Gazcorp Industrial Estate Modification 2 & DHL Warehouse and Distribution Centre SSD

State Significant Development Modification Assessment (SSD-5248-MOD-2) and

State Significant Development Assessment (SSD-36156297)

December 2022

Figure 10 | Proposed Site Accesses and B-Double Parking Areas

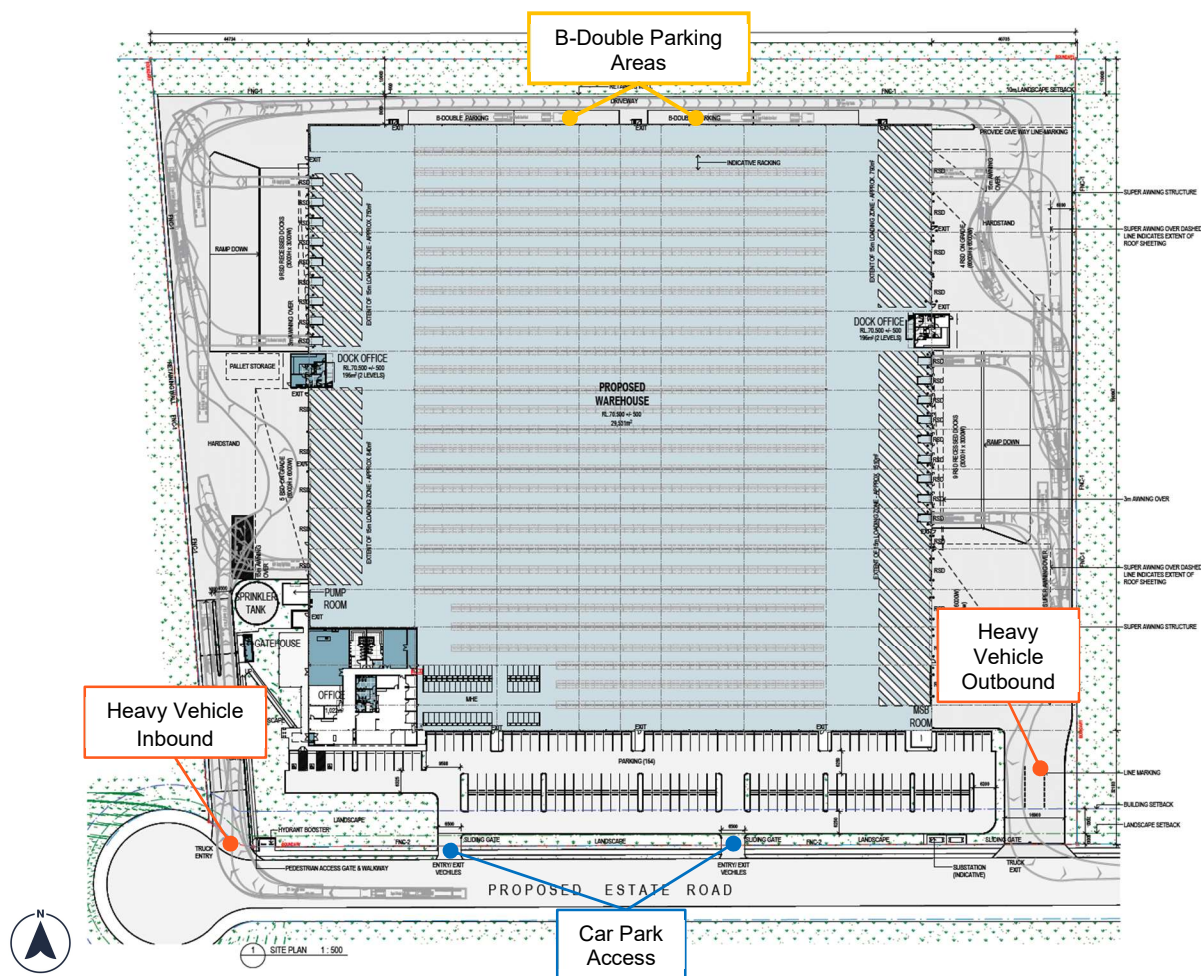
Council identified the proposed driveway connection from the DHL warehouse to the approved estate road network would not adequately accommodate turning B-double trucks, creating a potential safety issue. DHL revised the design to widen the truck exit driveway and provided swept path diagrams demonstrating that B-doubles could exit the driveway without crossing the centreline of the estate road. Council considered the revised design and recommended 'No Stopping' signs be installed along the estate road network to maintain truck manoeuvrability and road safety. Council also raised concerns about the design of the approved estate road network, requesting the Applicant undertake a Road Safety Audit and implement corrective actions to address the findings. The Applicant provided a Road Safety Audit in December 2022 as requested by Council.

Council noted the matters regarding stormwater management, air quality and noise impacts were adequately addressed. Council recommended conditions for a loading management plan, installation of 'no stopping' restrictions along the estate roads and preparation of a Road Safety Audit to ensure road capacity is adequate for the intended vehicles. Council reiterated the need to widen the heavy vehicle exit driveway onto the estate road to ensure trucks would not have to cross the centre line and potentially conflict with on-coming traffic.

In November 2022, the Applicant provided an amended site plan and landscape plan for the DHL warehouse showing a widened heavy vehicle exit driveway. The site plan included swept path diagrams indicating that a 26-metre B-double could exit the driveway without crossing the centre line of the estate road. The landscape plan removed a weed species from the planting schedule.

Given Council's concerns with the safety of the estate road network, the Department has recommended Gazcorp develop recommendations to address the findings of the Road Safety Audit and provide a timetable for implementation, to the satisfaction of the Planning Secretary. The Department has also included requirements for future development applications within the Concept Plan to demonstrate that all accesses to the estate road network are designed to minimise road safety risks and considers the cumulative impacts of other driveways within the Concept Plan. With these measures in place, the Department's assessment concludes the safety of the estate road network would be considered and addressed at each stage of development of the Concept Plan. The Department has also recommended Gazcorp install no stopping signs along the estate roads to maintain manoeuvrability and sight distances.
